**Bridge Factors Factual Report Attachment 45 – FDOT Structures Design Office (SDO)
electronic review and email comments on submittal phases for the signature pedestrian
bridge**

HWY18MH009

434688-1: FIU UNIVERSITY CITY PROSPERITY PROJ. ALONG SW 109 AVE & SR 90/SW 8 ST

4. Sheet B-4:

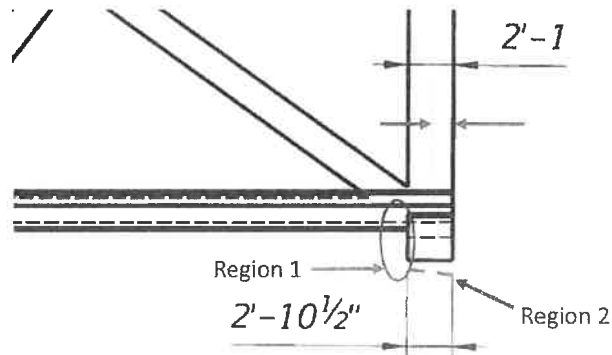
- a. Show cross slope on both sides of the section.
- b. Gradual drainage pipe slopes will be difficult to maintain. Greater slopes would be self-cleaning. Also design-in sufficient longitudinal slope of canopy to avoid ponding water.

Provide pipe cleanout details during final design and verify that 8 inch diameter pipe is sufficient.

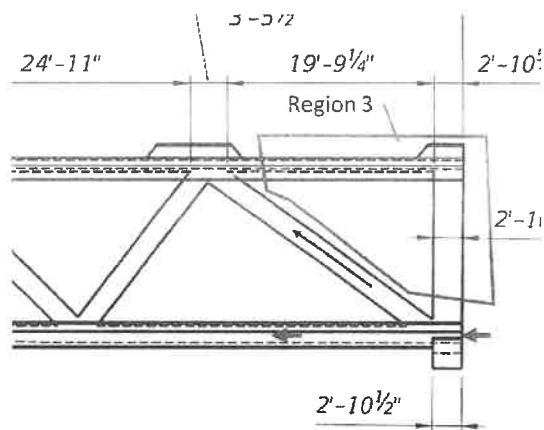
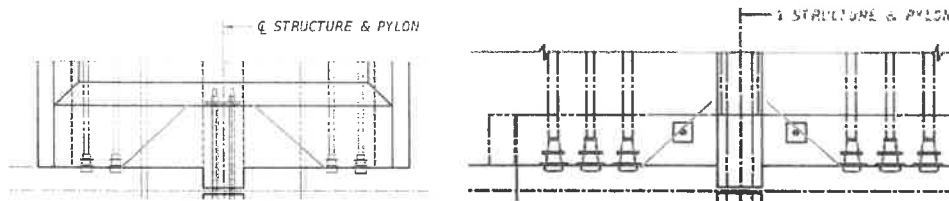
- c. There is a concern with tension behind the compression zone due to longitudinal PT of the walkway at the member ends as the top of the web and canopy element gets dragged along (shear lag in region 3).

- d. There appears to be significant shear lag issues in both the canopy and walkway as the stiff web element is being dragged behind the compression zone. The designer needs to pay particular attention in these areas. Moving the canopy continuity tendon to the middle tendon spot may improve the issue. Consider adding additional longitudinal tendons in the added 2 ft. corner chamfers (Comment 4.c.i).

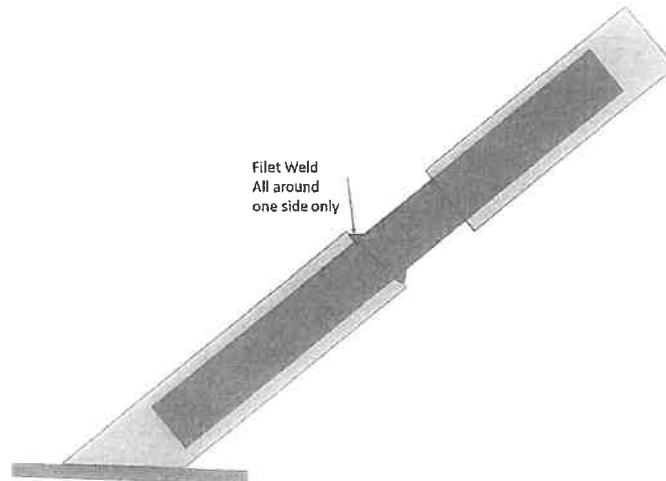
- Are the anchor bolts to be embedded in the members? Avoid drill and epoxy options if possible. See suggested detail below in item C to facilitate fit-up.

- c. The pipes will be a maintenance issue long term. Will they be galvanized and then painted. How will inside of pipe be maintained if it is not galvanized? Pipes will attract live loads, thermal loads, and wind loads. See suggested detail (tight fitting inner slide pipe) below to avoid stressing of the pipes. Require pipes to be completely sealed against rain intrusion.

- d. Given the sharply acute angles - How is quality welded insured? Also it is nearly impossible to inspect / perform NDT.

12. Sheet B-17:

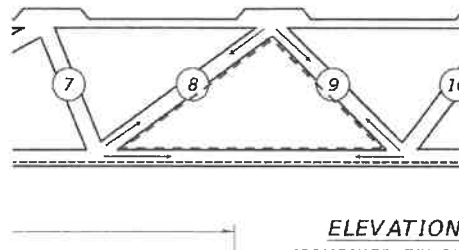
- a. See comment 8 above regarding providing a detailed stressing sequence. All web members may have to be stressed (even members 1, 9, 11 thru 14 and 24) to avoid cracking. See Comment 8.c above.
- b. The PT bars at the bottom joint intersection member 7 and 8 conflict (the bars are in the same vertical plane).
- c. In the case where the bars are stressed from the bottom, how is stressing accessed? Also if an anchor recess is provided at this location, the recess will weaken the member.
- d. Include reinforcing and bursting steel details in the next submittal.
- e. Recommend showing section views for members without PT bars.

- f. The web truss will be very difficult to form without shrinkage cracking of the geometrically constrained members. Concrete placed around rigid inner forms are prone to shrinkage cracking and difficult to strip without damaging the member. See sketch below. Also over the length of the web element how will shrinkage be facilitated – will the inner forms be allowed to float or will the element be cast in stages? Recommend a shrinkage reducing admixture, a staged construction process and possibly call-for all of the inner forms to be lined with thin compressible rubber liners.

4. Sheet B-4:

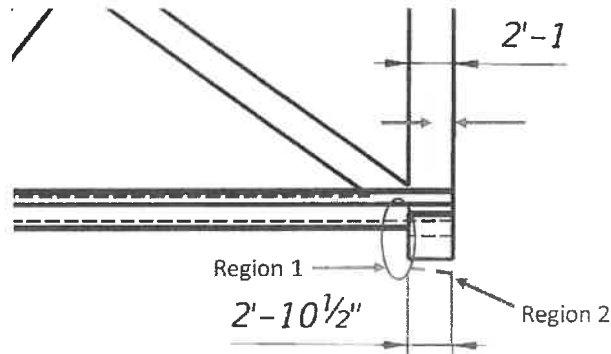
- a. Show cross slope on both sides of the section.
- b. Gradual drainage pipe slopes will be difficult to maintain. Greater slopes would be self-cleaning. Also design-in sufficient longitudinal slope of canopy to avoid ponding water.

Provide pipe cleanout details during final design and verify that 8 inch diameter pipe is sufficient.

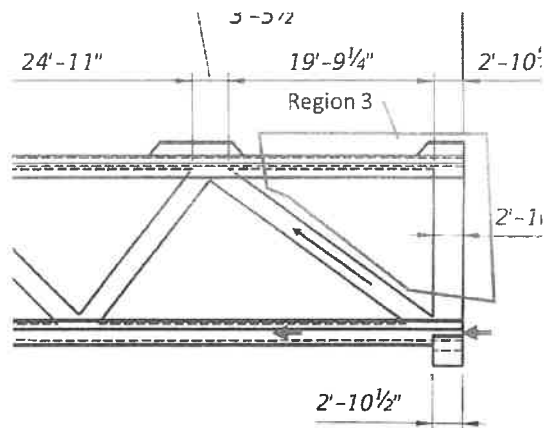
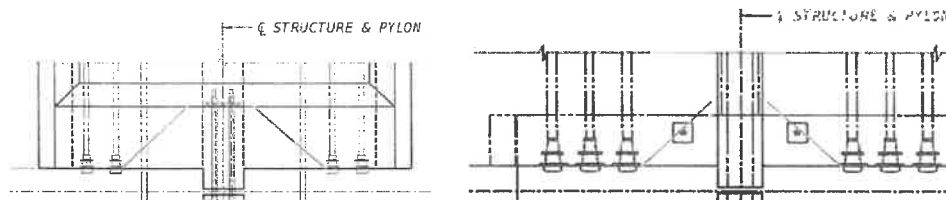
- c. There is a concern with tension behind the compression zone due to longitudinal PT of the walkway at the member ends as the top of the web and canopy element gets dragged along (shear lag in region 3).

- d. There appears to be significant shear lag issues in both the canopy and walkway as the stiff web element is being dragged behind the compression zone. The designer needs to pay particular attention in these areas. Moving the canopy continuity tendon to the middle tendon spot may improve the issue. Consider adding additional longitudinal tendons in the added 2 ft. corner chamfers (Comment 4.c.i).

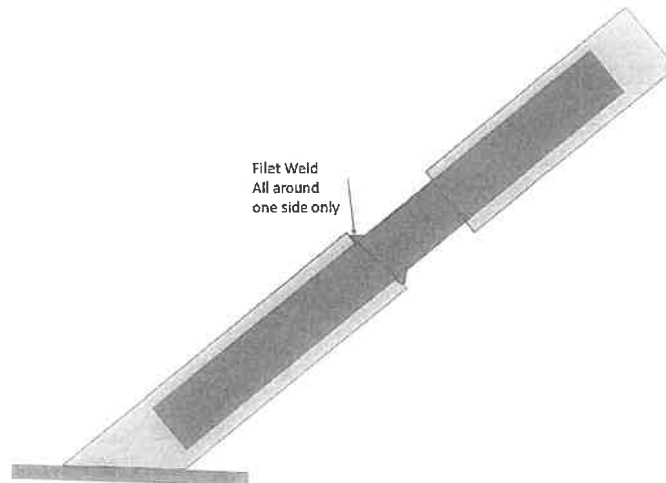
- Are the anchor bolts to be embedded in the members? Avoid drill and epoxy options if possible. See suggested detail below in item C to facilitate fit-up.

- c. The pipes will be a maintenance issue long term. Will they be galvanized and then painted. How will inside of pipe be maintained if it is not galvanized? Pipes will attract live loads, thermal loads, and wind loads. See suggested detail (tight fitting inner slide pipe) below to avoid stressing of the pipes. Require pipes to be completely sealed against rain intrusion.

- d. Given the sharply acute angles - How is quality welded insured? Also it is nearly impossible to inspect / perform NDT.

12. Sheet B-17:

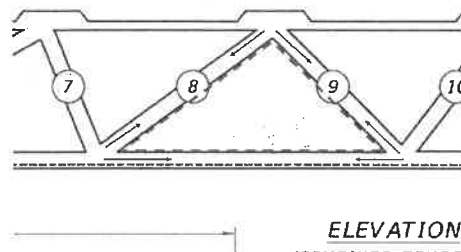
- a. See comment 8 above regarding providing a detailed stressing sequence. All web members may have to be stressed (even members 1, 9, 11 thru 14 and 24) to avoid cracking. See Comment 8.c above.
- b. The PT bars at the bottom joint intersection member 7 and 8 conflict (the bars are in the same vertical plane).
- c. In the case where the bars are stressed from the bottom, how is stressing accessed? Also if an anchor recess is provided at this location, the recess will weaken the member.
- d. Include reinforcing and bursting steel details in the next submittal.
- e. Recommend showing section views for members without PT bars.

- f. The web truss will be very difficult to form without shrinkage cracking of the geometrically constrained members. Concrete placed around rigid inner forms are prone to shrinkage cracking and difficult to strip without damaging the member. See sketch below. Also over the length of the web element how will shrinkage be facilitated – will the inner forms be allowed to float or will the element be cast in stages? Recommend a shrinkage reducing admixture, a staged construction process and possibly call for all of the inner forms to be lined with thin compressible rubber liners.

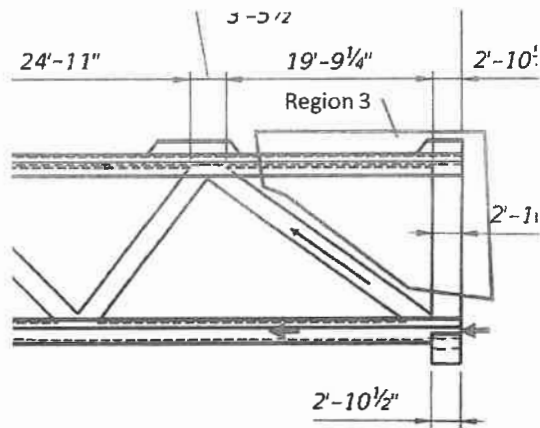
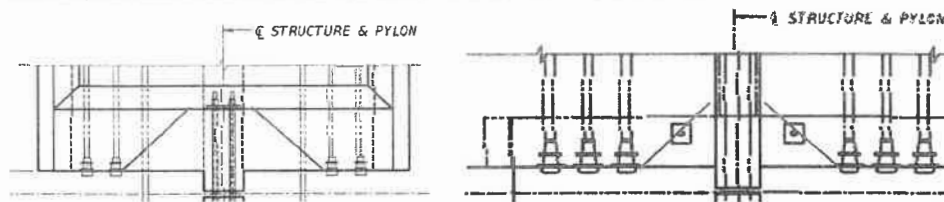
- c. There is a concern with tension behind the compression zone due to longitudinal PT of the walkway at the member ends as the top of the web and canopy element gets dragged along (shear lag in region 3).

- d. There appears to be significant shear lag issues in both the canopy and walkway as the stiff web element is being dragged behind the compression zone. The designer needs to pay particular attention in these areas. Moving the canopy continuity tendon to the middle tendon spot may improve the issue. Consider adding additional longitudinal tendons in the added 2 ft. corner chamfers (Comment 4.c.i).

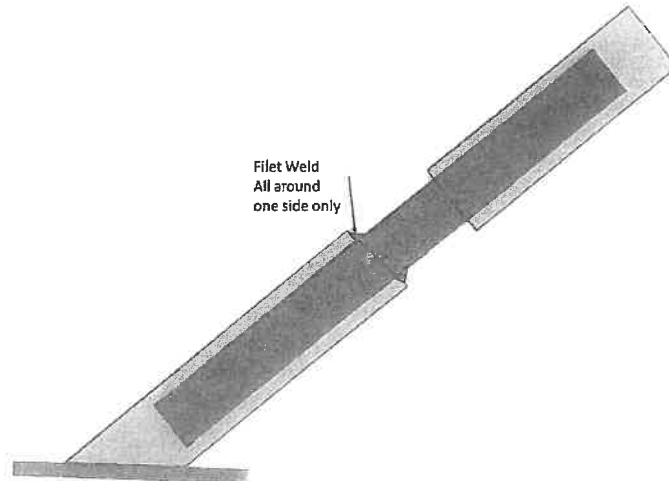
- Are the anchor bolts to be embedded in the members? Avoid drill and epoxy options if possible. See suggested detail below in item C to facilitate fit-up.

- c. The pipes will be a maintenance issue long term. Will they be galvanized and then painted. How will inside of pipe be maintained if it is not galvanized? Pipes will attract live loads, thermal loads, and wind loads. See suggested detail (tight fitting inner slide pipe) below to avoid stressing of the pipes. Require pipes to be completely sealed against rain intrusion.

- d. Given the sharply acute angles - How is quality welded insured? Also it is nearly impossible to inspect / perform NDT.

12. Sheet B-17:

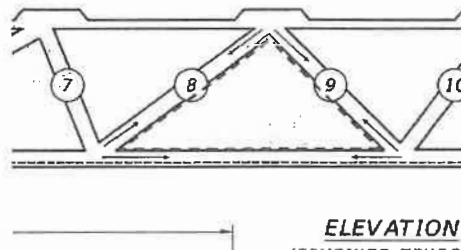
- a. See comment 8 above regarding providing a detailed stressing sequence. All web members may have to be stressed (even members 1, 9, 11 thru 14 and 24) to avoid cracking. See Comment 8.c above.
- b. The PT bars at the bottom joint intersection member 7 and 8 conflict (the bars are in the same vertical plane).
- c. In the case where the bars are stressed from the bottom, how is stressing accessed? Also if an anchor recess is provided at this location, the recess will weaken the member.
- d. Include reinforcing and bursting steel details in the next submittal.
- e. Recommend showing section views for members without PT bars.

- f. The web truss will be very difficult to form without shrinkage cracking of the geometrically constrained members. Concrete placed around rigid inner forms are prone to shrinkage cracking and difficult to strip without damaging the member. See sketch below. Also over the length of the web element how will shrinkage be facilitated – will the inner forms be allowed to float or will the element be cast in stages? Recommend a shrinkage reducing admixture, a staged construction process and possibly call for all of the inner forms to be lined with thin compressible rubber liners.

SHEET TITLE: MAIN SPAN TRUSS SYSTEM LAYOUT

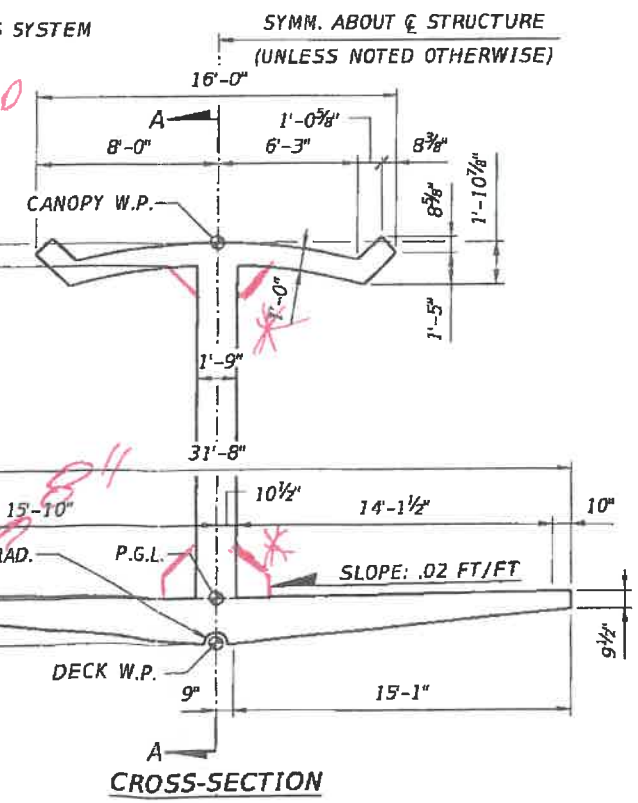
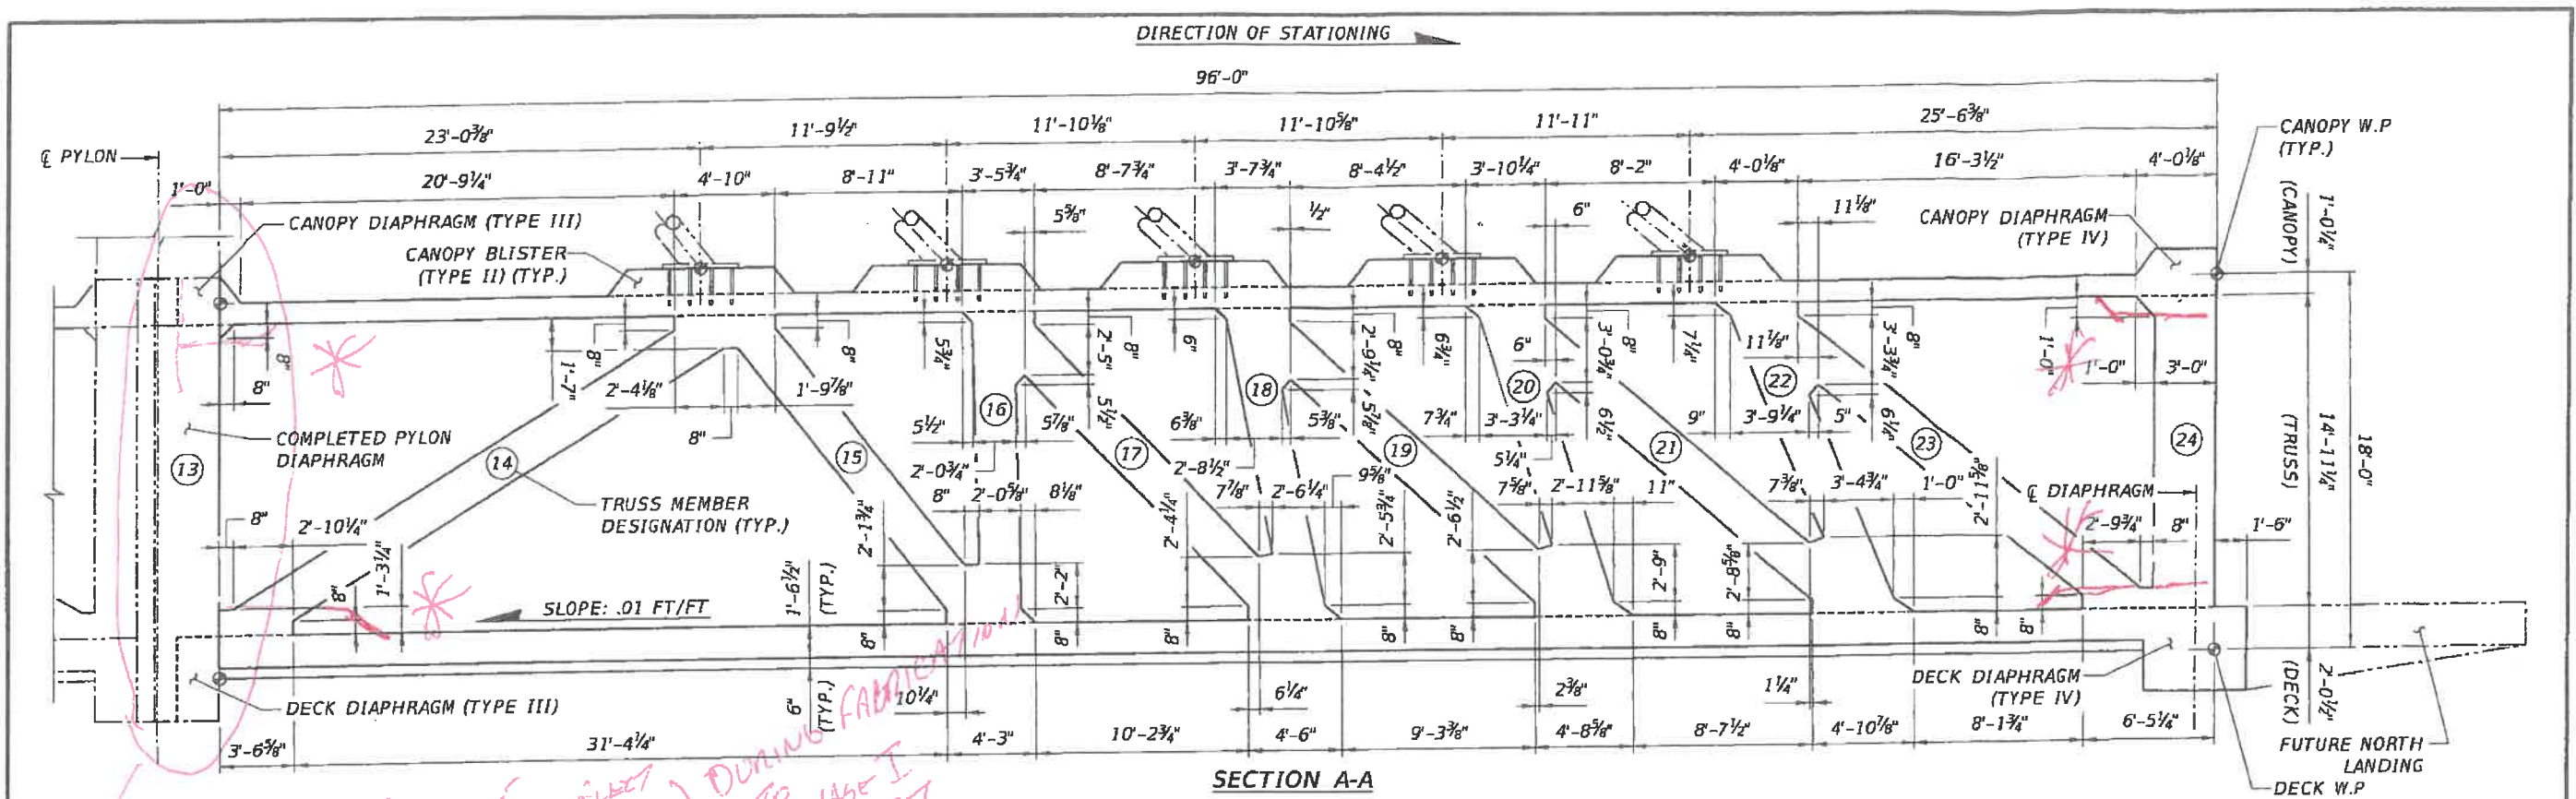
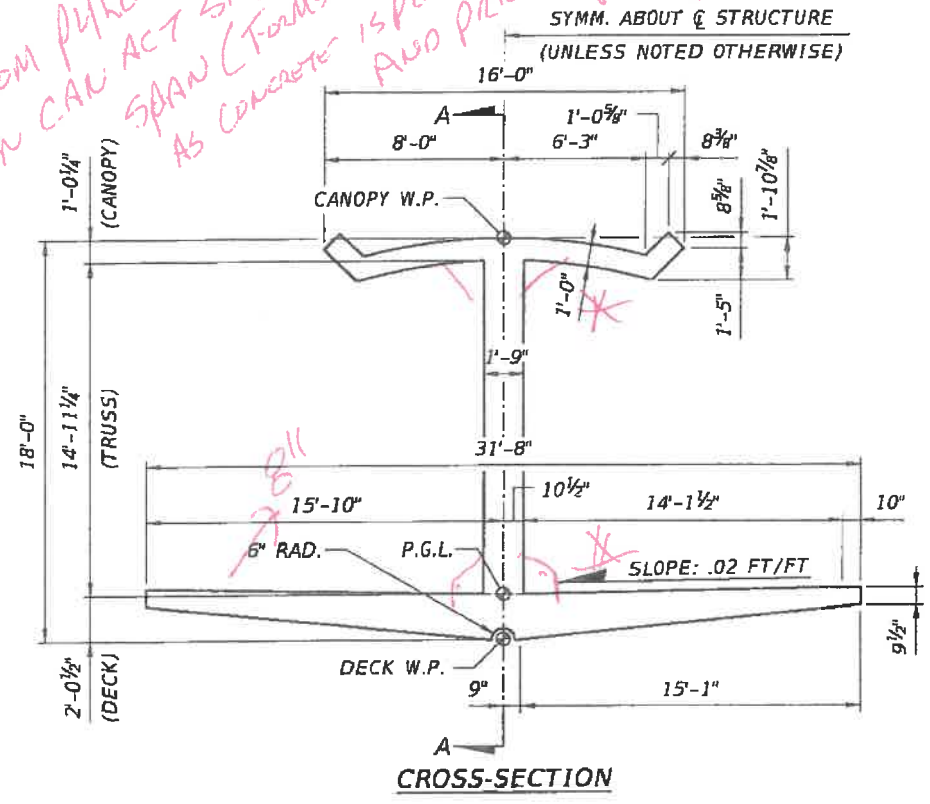
** RECOMMEND CHAMFERED END BLOCKS TO ADDRESS SHEAR LAG @ ANCHORS*

ISOLATE SPAN FROM PYLON SO SPAN CAN ACT SIMPLE SPAN (FORMS RELEASE AS CONCRETE IS PLACED) DURING FABRICATION AND PRIOR TO PHASE I P.T.

** RECOMMEND CLAMPED END BLOCKS TO ADDRESS SHEAR LAG @ ANCHORS.*

SHEET TITLE: MAIN SPAN END DIAPHRAGM REINFORCEMENT I - TYPE IV
 ROAD NO. COUNTY PROJECT ID PROJECT NAME SHEET NO.
 MIAMI - DADE 434688-1-58-01 UNIVERSITY CITY PROSPERITY PROJECT B-54

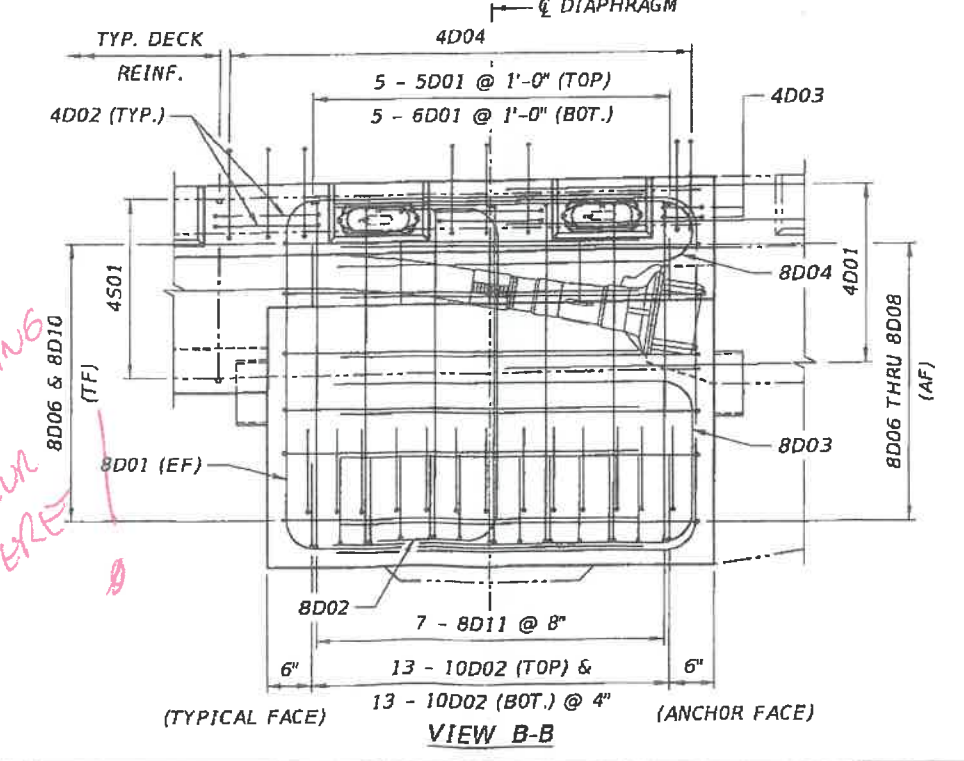
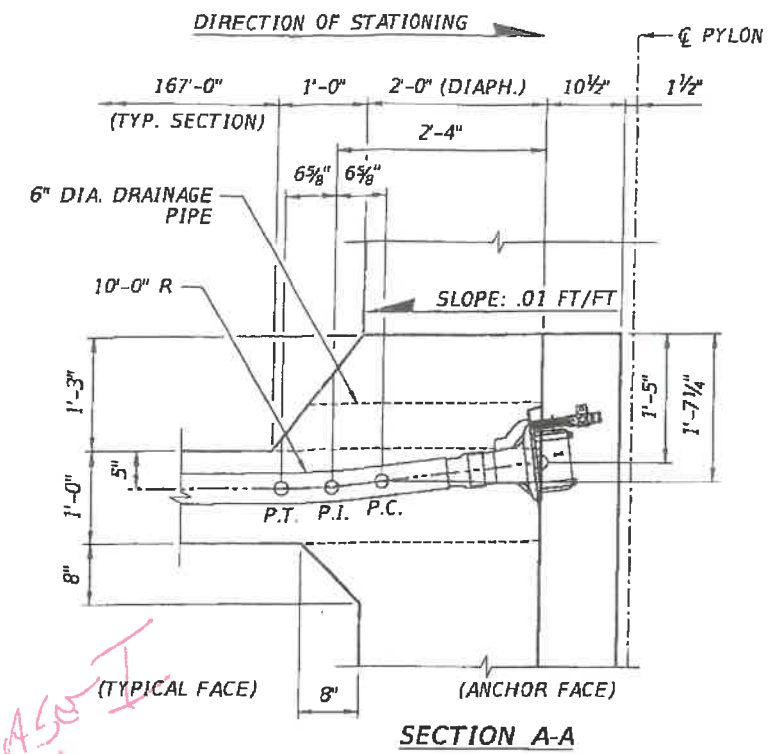
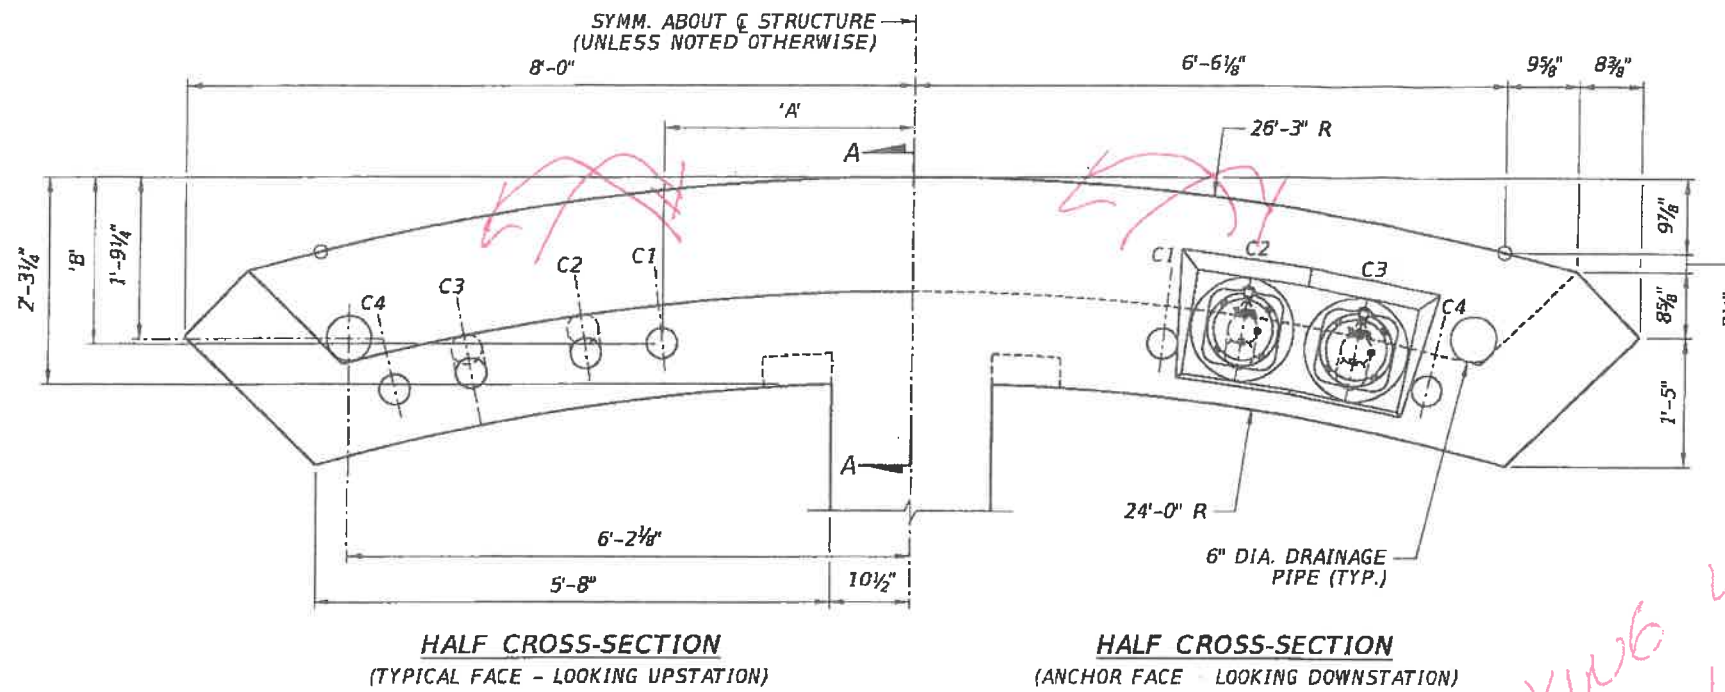
*CRACKING
WILL
OCCUR
HERE*
